SUNDRY NOTICES AND REPORTS ON WELLS
Do not use this form for proposals to drill or to re-enter an abandoned well. Use Form 3160-3 (APD) for such proposals.

8. Well Name and No.
Cindy Federal #1

**Cindy Federal 1
30-005-61063
Vanguard Operating, LLC
April 8, 2019
Conditions of Approval**

AFTER P&A

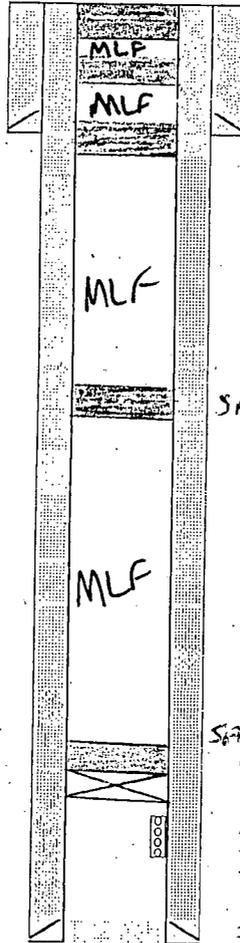
- 1. Operator shall place CIBP at 2,604' (50'-100' above top most perf) and place 25 sx of Class C cement on top to seal the Abo Formation. WOC and TAG.**
- 2. Operator shall place a Class C cement plug from 2,004'-1,884' as proposed.**
- 3. Operator shall place a Class C cement plug from 1,467'-1,367' as proposed to seal the 8-5/8" shoe. WOC and TAG.**
- 4. Operator shall place a Class C cement plug from 510'-410' as proposed.**
- 5. Operator shall place a Class C cement plug from 336'-surface as proposed to seal the Glorieta.**
- 6. See Attached for general plugging stipulations.**
